**VIRGINIA ELECTRIC AND POWER COMPANY**  
**SURRY POWER STATION UNITS 1 AND 2**  
**RESPONSE TO REQUEST FOR ADDITIONAL INFORMATION**  
**2006 STEAM GENERATOR INSERVICE INSPECTION REPORTS**

**Response to NRC Request for Additional Information Regarding  
2006 Steam Generator Inservice Inspection Reports**

**Surry Power Station Units 1 and 2**

**REQUEST FOR ADDITIONAL INFORMATION**  
**REGARDING STEAM GENERATOR INSERVICE**  
**INSPECTION REPORTS FOR THE 2006 REFUELING OUTAGES**

**Leak Rate and Pressure versus Time Plot for the In-situ Pressure Test  
Performed on Tube Row 35 Column 68 in the “A” Steam Generator**

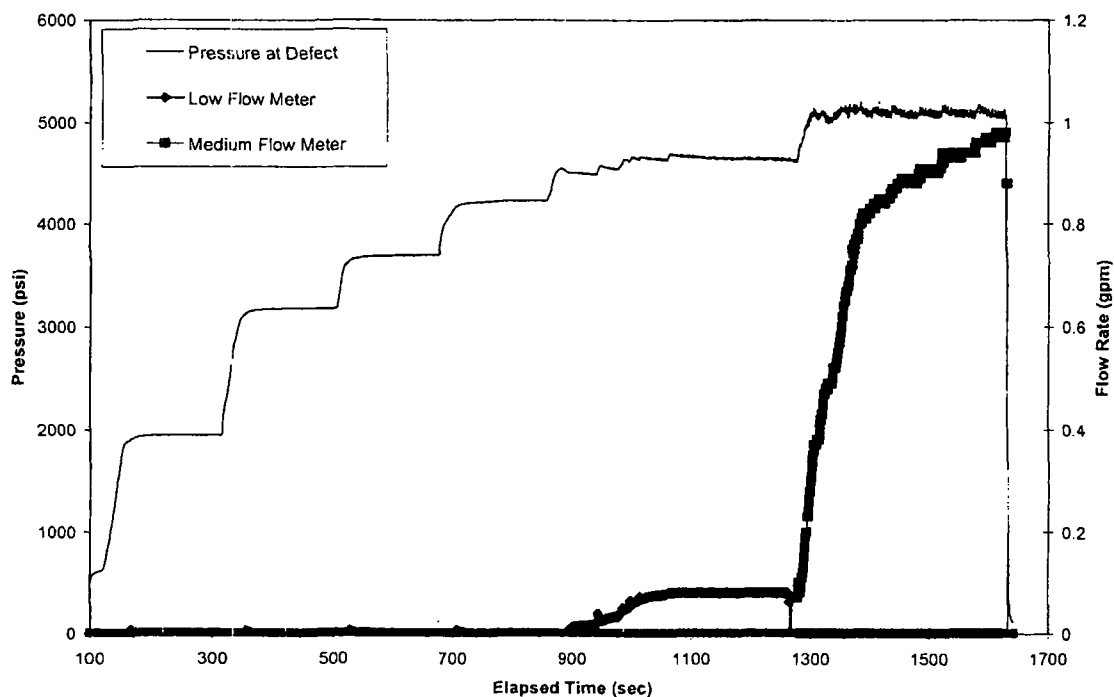
3. *During the Surry 1 outage, there was extensive discussion concerning the in-situ pressure test of Tube Row 35 Column 68 in SG A. Please provide a copy of the leak rate and pressure versus time plot for this in-situ pressure test (for historical reference).*

A copy of the leak rate and pressure versus time plot for the in-situ pressure test performed on Tube Row 35 Column 68 in Surry Unit 1 SG A is provided in the attachment to this enclosure. As noted on the plot, the information provided is for the second in-situ test that was performed on the subject tube. The first in-situ test attempt was aborted due to a faulty medium flow meter that required replacement prior to completing the test.
